TOWN OF
BRECKENRIDGE

Planning Commission Meeting Agenda

Monday, June 4, 2018, 5:30 PM

Planning Commission Staff Report

MASTER SITE PLAN AREA CALCS AND NOTES
A111

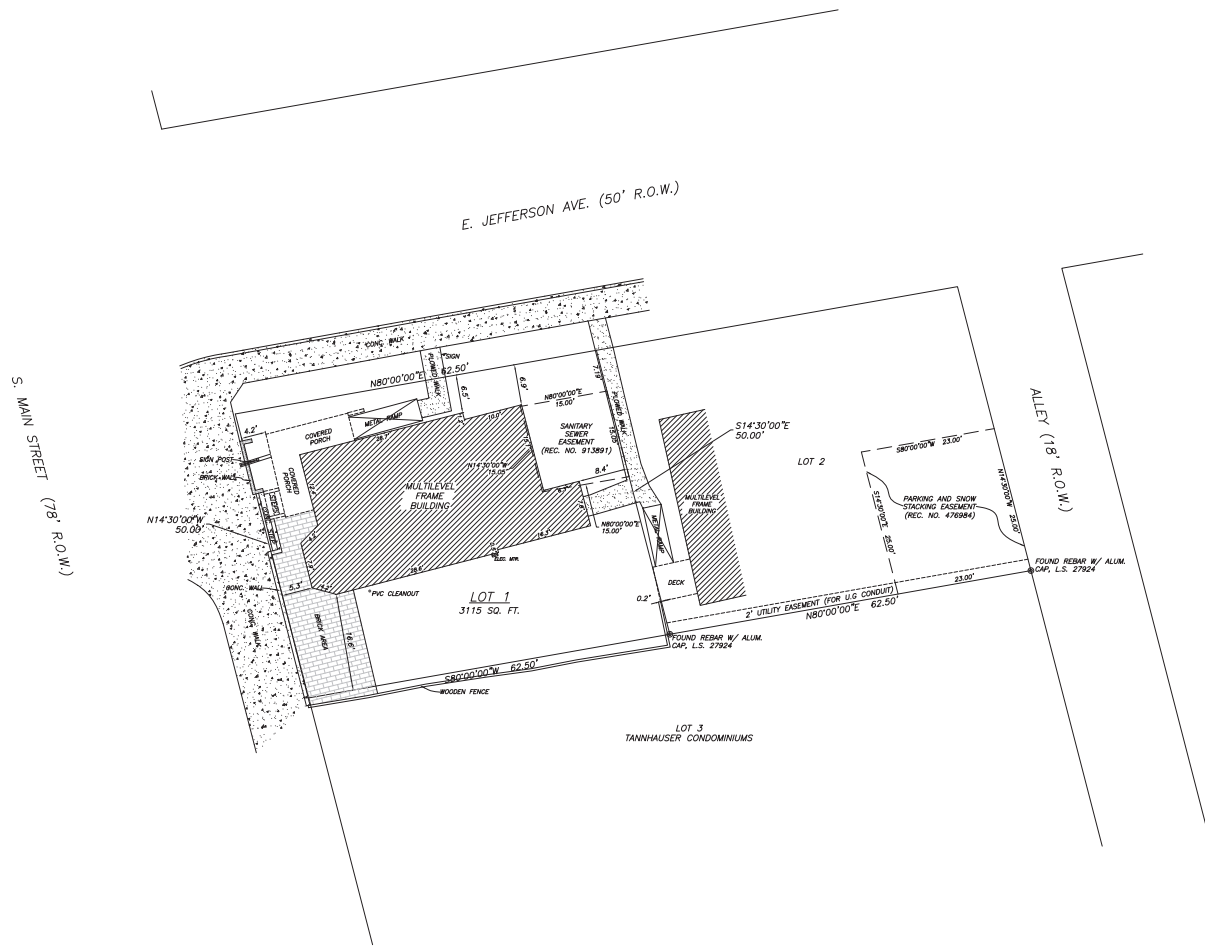
Staff requires that the site plan specify these calculations prior to the Final Hearing, so that staff may confirm the front yard is in compliance with this Design Standard. As proposed, the front yard does not appear to be in compliance. Regarding the proposed patio in the side yard, does the Planning Commission find that the residential character of the side yard is being maintained, as required by this Standard?

Snow Removal and Storage (13/A & 13/R): The site plan shows 118 sq. ft. of designated snow storage area, at the northeast corner of the building, in the area of the utility easement. Prior to the Final Hearing, staff will require that the site plan be revised to specify the area of the walkways required to be cleared of snow, so that staff can confirm the 25% snowstacking requirement is being met. Some functional snow storage area will need to be designated near the front entrance of the building.

EXISTING EXTERIOR ELEVATIONS
A301

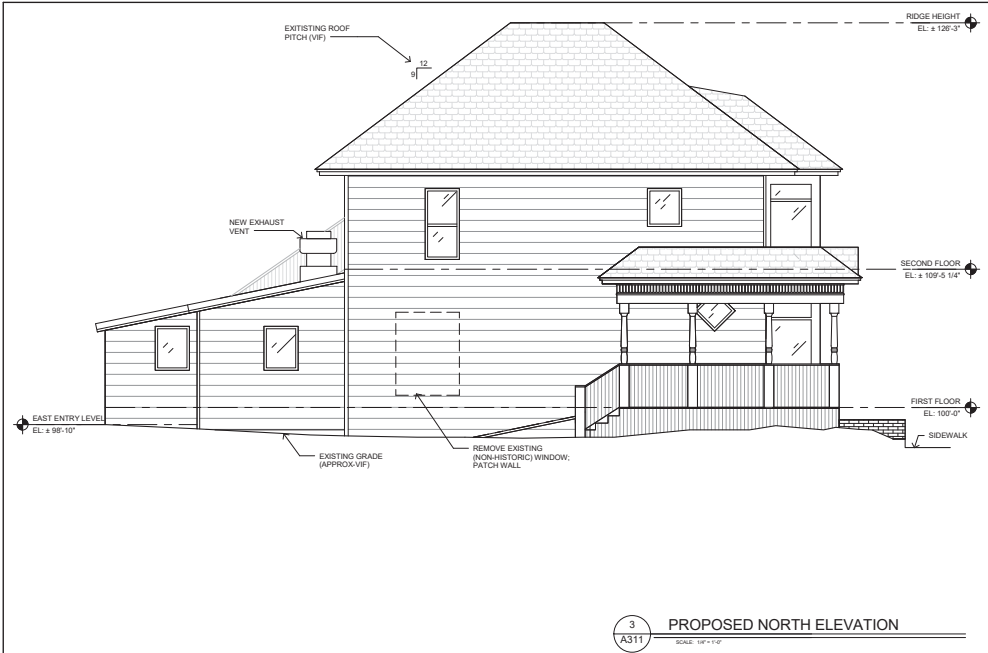
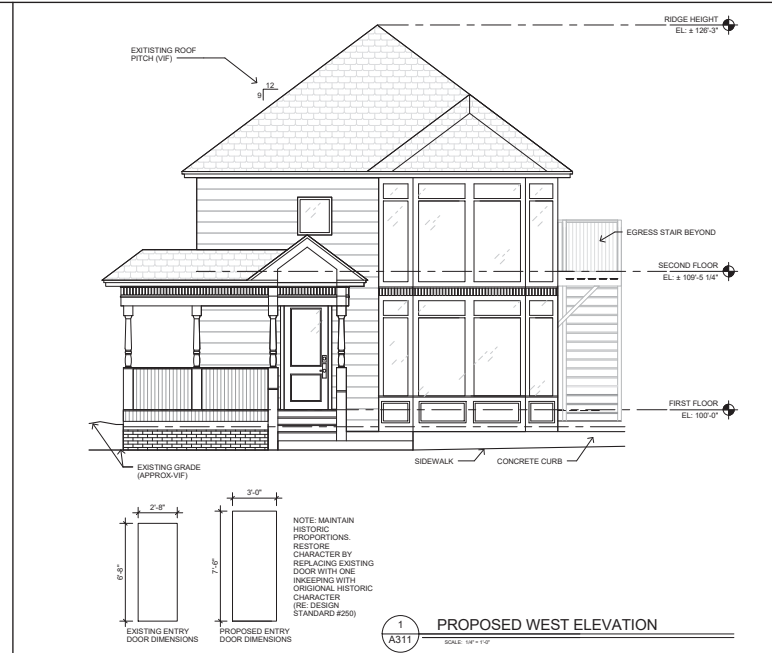
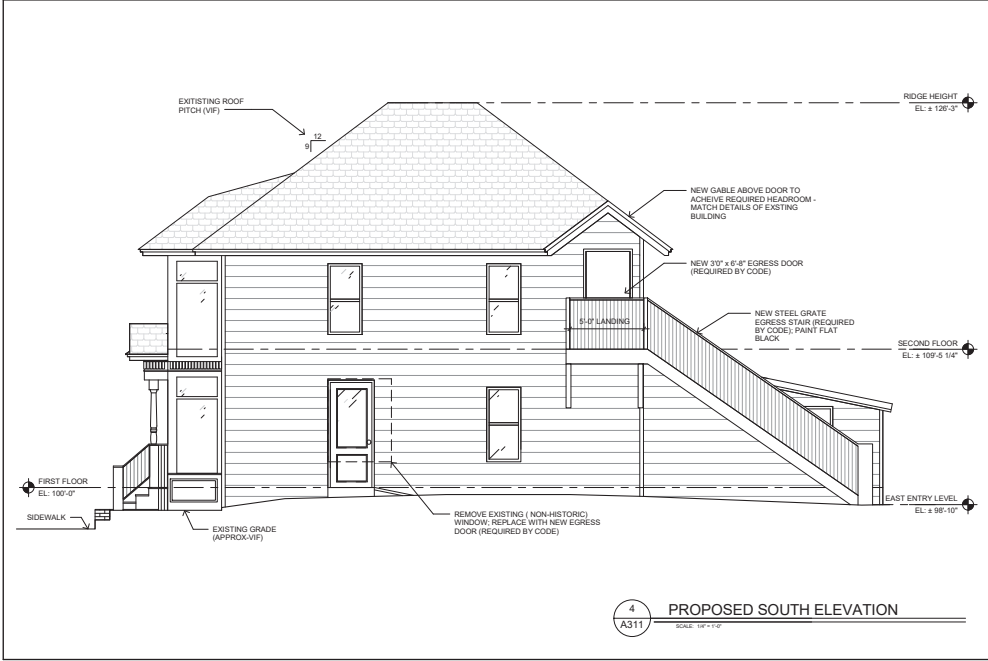
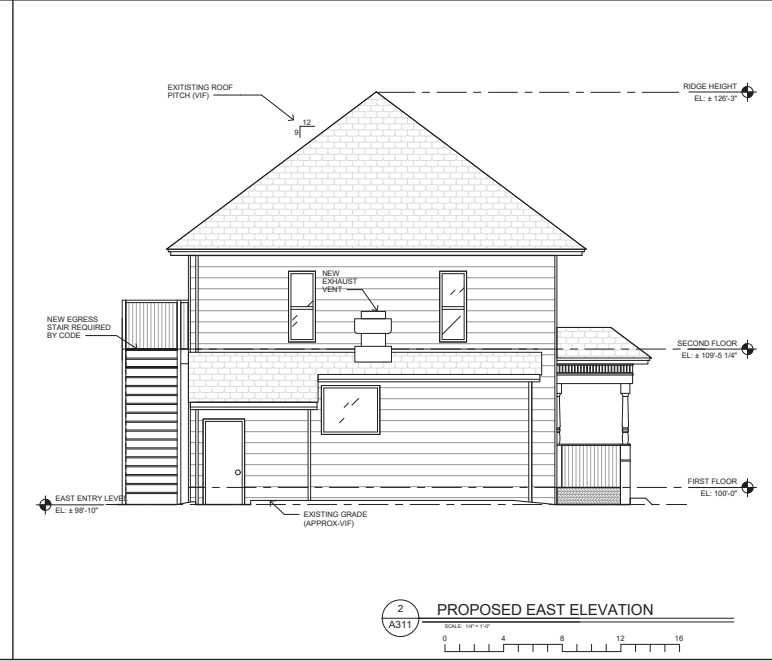
- **Design Standard 243:** This Standard recommends that the typically simple character of roofs be maintained. This building is one of two “foursquare” style buildings in Breckenridge, meaning the roof form is a character defining feature of the building. However, the front portion of the building’s roof has been modified with the 1970s front façade modification, resulting in its “non-contributing” status. In order to open the second floor of the building to patrons of the restaurant, the Building Code requires egress to the second floor and for the door opening to have standard headroom clearance, hence the proposed exterior stairs and small gabled roof addition over the new second story door. Because the building has been substantially altered from its historic form, and the second story access and headroom is required for the second floor to be used by the public, staff finds the small gable roof acceptable. Does the Commission agree?

1. Is the Commission supportive of the proposed change of use?
2. Regarding Priority Design Standard 236, does the Commission find that the residential character of the side yard is being maintained with the proposed paver patio?
3. Regarding Priority Design Standard 243, does the Commission agree that the character of the building's roof will be maintained with the addition of the small gable over the new 2nd story door?
4. Does the Commission agree with the preliminary point analysis?

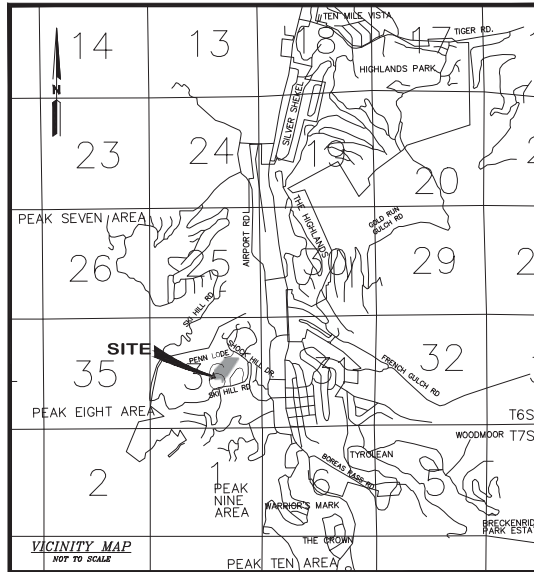
1. Staff recommends the developer landscape the center of the cul-de-sac and have the HOA maintain the area as open space to minimize unnecessary hard surface areas. Does the Commission agree?
2. Does the Commission have any additional comments on the proposed subdivision design?
